Planning Commission Minutes
December 14, 2023

16. (PUD-1979) Application by Portland One 50, LLC, to rezone 3261 NW 150th Street from I-2 Moderate Industrial District to PUD-1979 Planned Unit Development District. Ward 8.

STAFF REPORT
The City of Oklahoma City
Planning Commission
December 14, 2023

Item No. IV. 16.

CONCEPTUAL PLAN

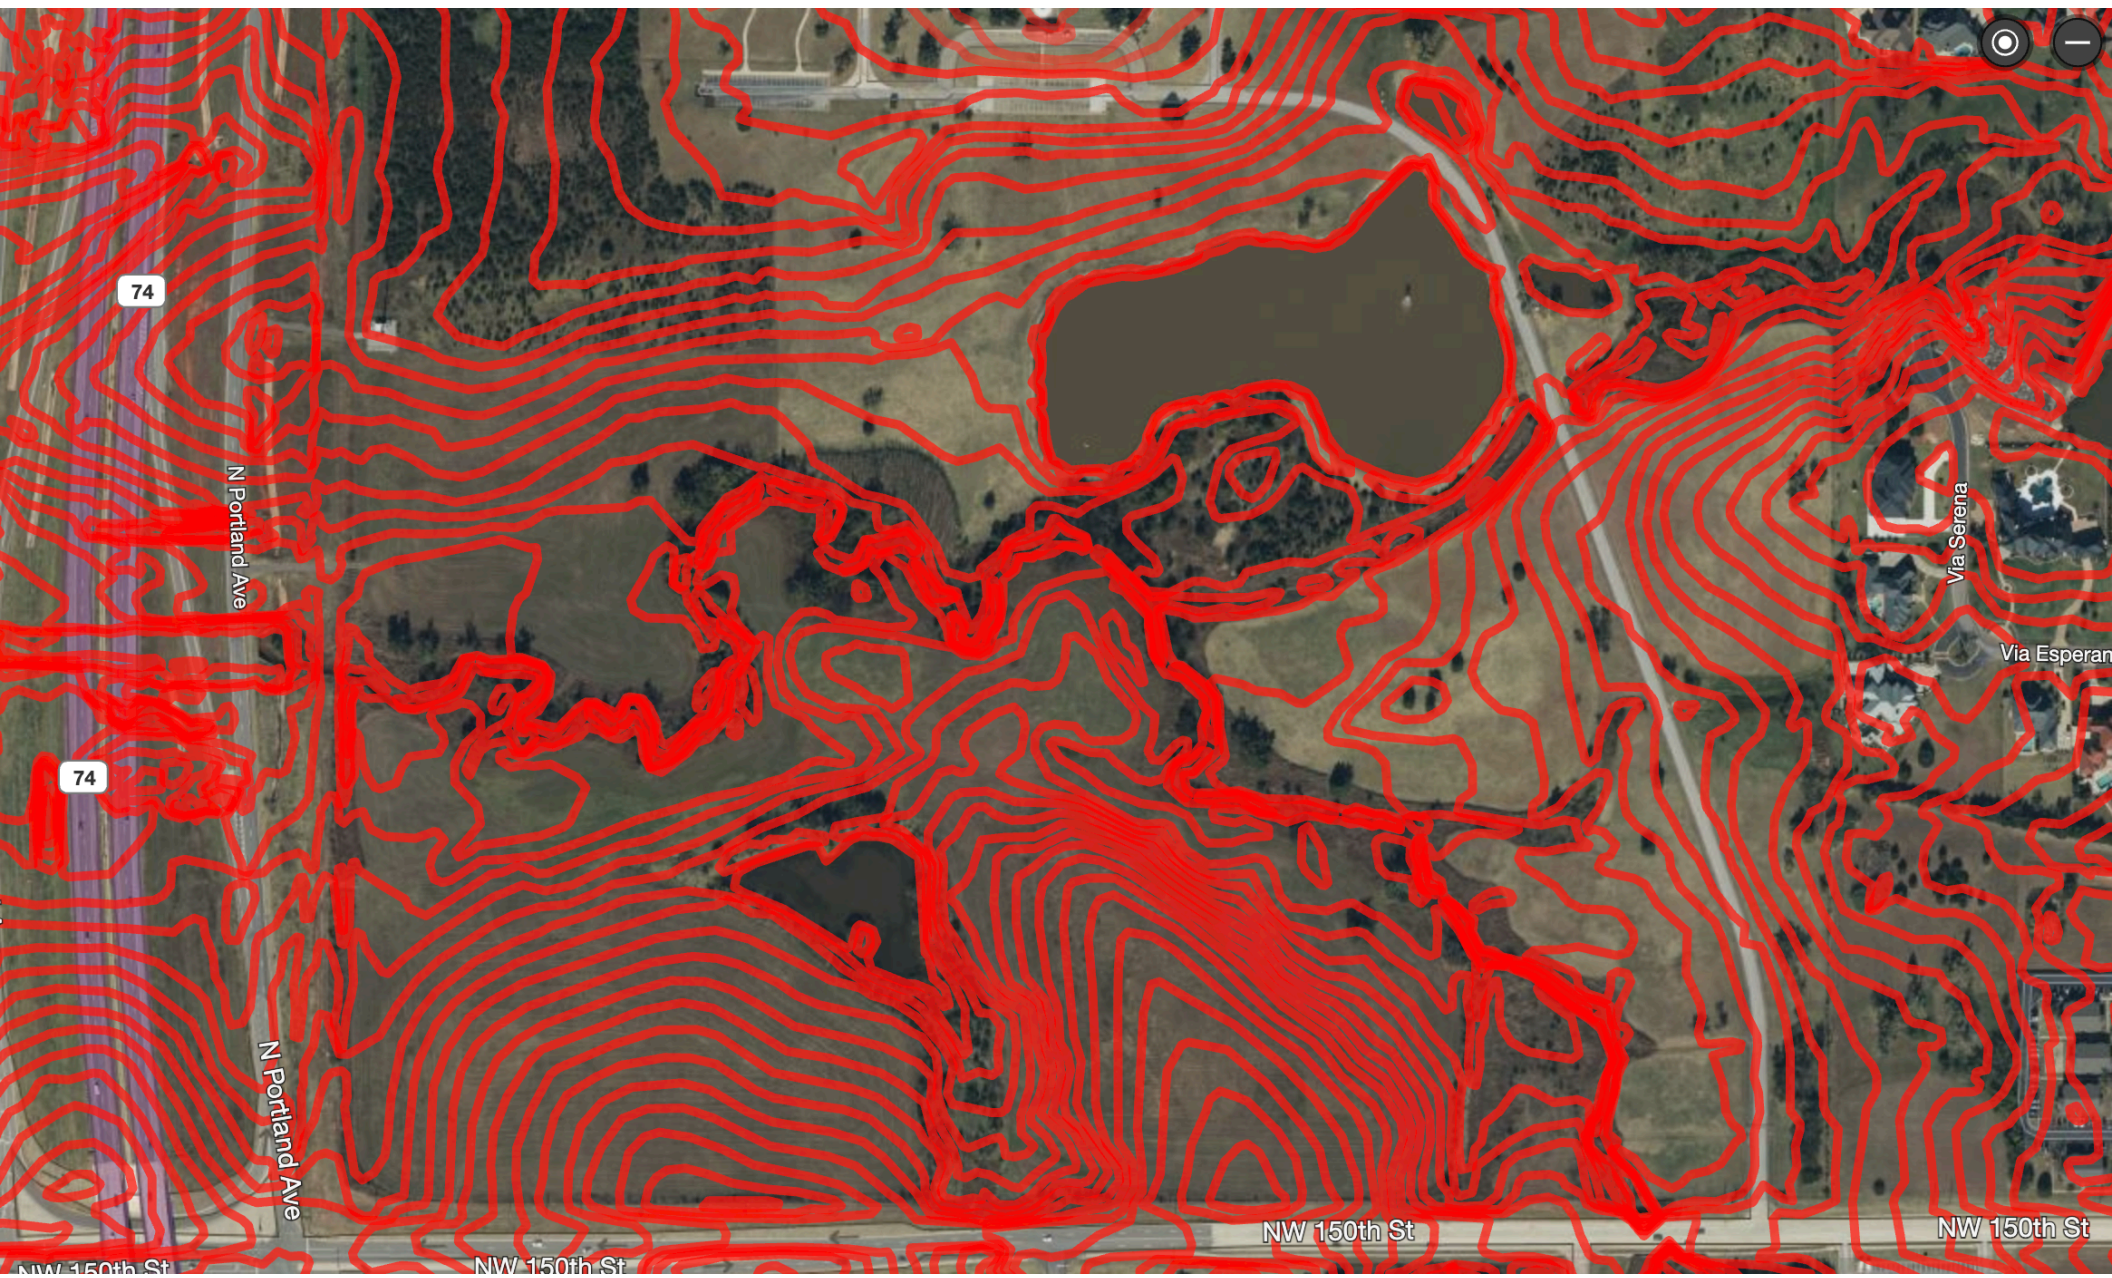
- 1. Airports**
- 2. Central Oklahoma Transportation and Parking Authority (COTPA)**
- 3. Fire:** No objection with secondary access drive running north as shown.
- 4. Information Technology/Geographic Support**
- 5. Parks and Recreation**
- 6. Police**

National, state, and local permitting require basic best management practices for stormwater management. Public water and sewer are available. The PUD is requested to add R-4 residential uses to the commercial and industrial uses already allowed on the site. The PUD establishes a maximum density of 25 du/acre. Conceptual plans indicate apartment buildings oriented toward the creek.

- Riparian areas: Riparian areas are vegetated areas adjacent to streams, lakes, ponds, and wetlands that are composed of a mixture of trees, shrubs, and grasses. These areas may also contain floodplain. The comprehensive plan recommends a 100-foot buffer from stream banks. *Riparian area in the form of streams and a pond are present along the perimeter of the west/north PUD boundary. The conceptual plan indicates apartment buildings facing the creek.*
